APPROVED MINUTES OF THE MEETING

September 17, 2009

September 17, 2009 Project: Shared Street

Phase: 60% Design

45th Street Site Plan

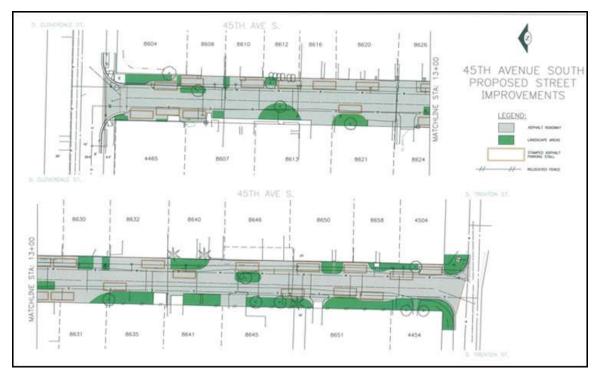
- Use as little regulatory (restrictive) signage as possible.
- Explore use curb sections, reflective buttons and/or paint to demarcate and clarify edges and functions.

- Consider establishing a design datum to visually tie together the variety of objects and treatments proposed in the right of way.
- Ensure that the roadway is safe and intuitive for night drivers and pedestrians as well as during the day.

- Consider using other more conventional materials and objects in an interesting and artistic way to demarcate functions in the right of way.

With the visitor parking, there's playfulness, but there should be some sort of prescriptive elements that would keep people from parking where they shouldn't.

Overall, the amount of landscaping that can go in because of this approach is wonderful. Some landscaping is only a few feet wide and long. Do these pieces connect into green on abutting property? Traffic circles that are small don't seem to fare well. I am concerned about small isolated islands; you may need a back-up plan. Consider a minimum size threshold. The islands could just get run over if there is no curbing. These are red flags to look at a few years down the road.

Is there lighting? Consider boundary of landscaping and asphalt.

It is powerful how the neighbors are coalescing. This type of project needs it. Edges are something you have power over. Give a unifying character to the edges; head on edges and corners especially.

Signage and clarity of use of parking, try to get away with as little signage as possible. Cue should be in design, and not from a lot of signs.

Use some type of painting and reflectors to show where to go and not where not to go.

The Fire Department is also concerned about this. In the present situation, there is parking all over the street. We tried to get parking in where possible without removing landscaping. There is a lot of off street parking in driveways, so there's room for visitors too. There are parking spaces in the right-of-way also though. Enforcement will be further explored.

The team is looking at these issues. We did base the location of plantings on where there were enough for a significant size and where they were likely to be maintained. We will revisit and find solutions as time passes.
